<p style="text-align: center;"> <small>           • MANUFACTURERS OF WIPLINE FLOATS &amp; SKIS            • SPECIALISTS IN AIRCRAFT MODIFICATION            1700 Henry Avenue - Fleming Field            South St. Paul, MN 55075            651-451-1205         </small> </p>			Rev / Latest Rev. Date B/ 11-26-08
			Original Release 11-20-08
Prepared by Ellen Parker	Aircraft Make / Model	Float / Ski Model Wipline 10000 Amphibious Floats	Page 1  2
	Title 10000 float baggage floor repair		
<b>ALL INFORMATION IN THIS SERVICE DOCUMENT BASED ON FAA APPROVED DATA</b>

## **SERVICE LETTER: 101**

**EFFECTIVITY:** All 10000 floats up to and including 10084A

FIGURE C

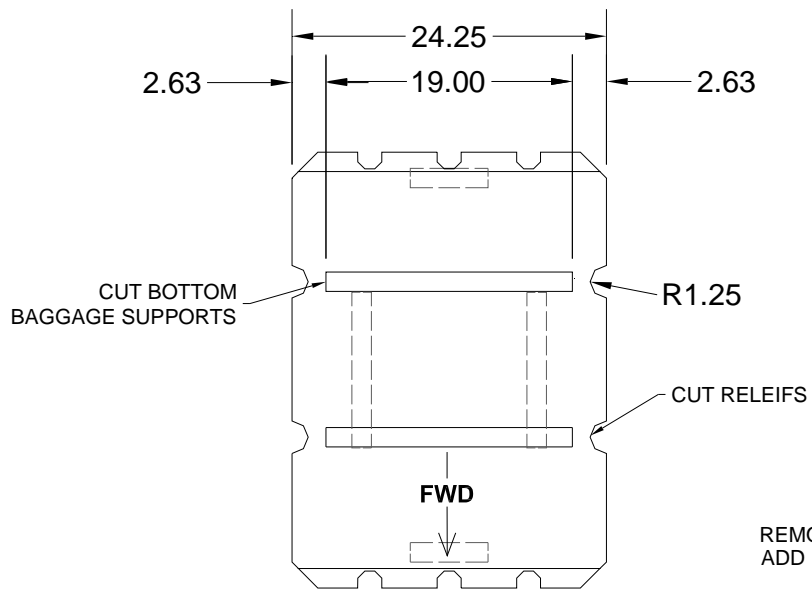
**If no damage** is found Wipaire recommends owner-operators cutting reliefs in the baggage floor as shown in **figure C, page 2 and installing Wipaire Service Kit 74.**

FIGURE A

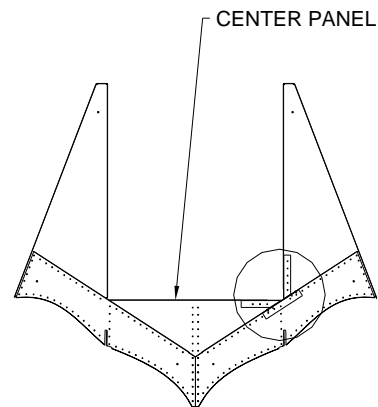
REMOVE PORTION OF FLANGE IF CRACKED.  
ADD REINFORCEMENT DOUBLER.

FIGURE B

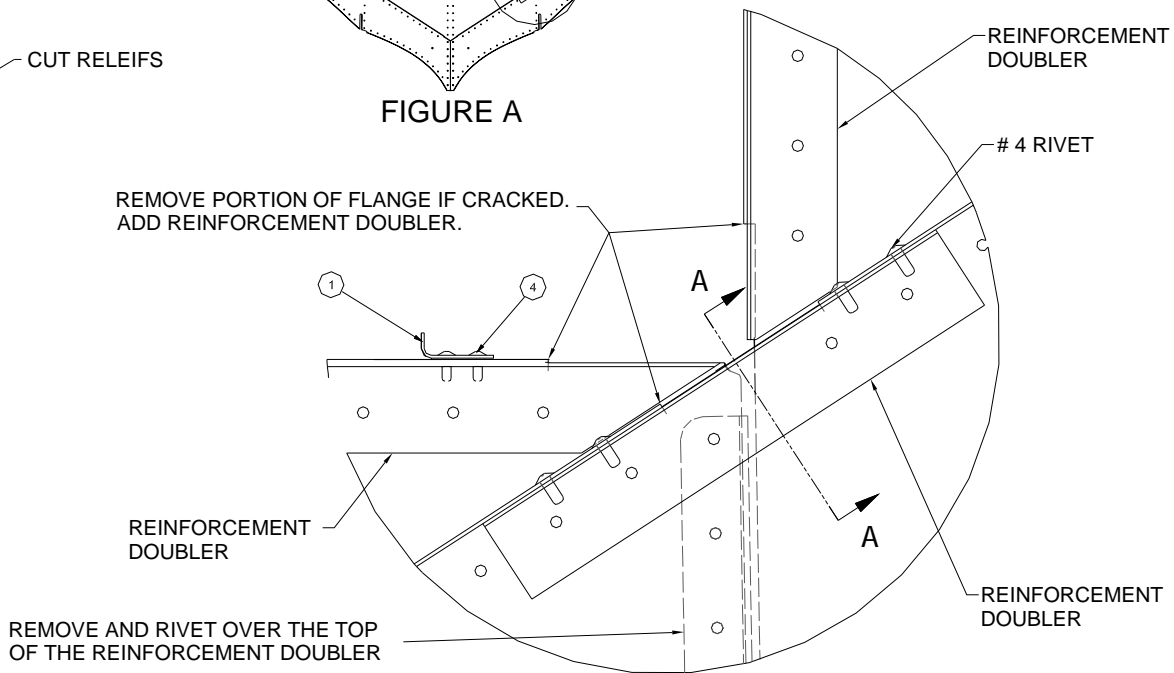
**METHOD OF COMPLIANCE:** If, after the regularly scheduled inspections, **damage is found** on the baggage bulkheads, operators may use **page 2** as instructions for the repair. This repair includes reinforcing the central panel with doublers (figures A & B) and cutting reliefs into the baggage compartment floor (figure C).
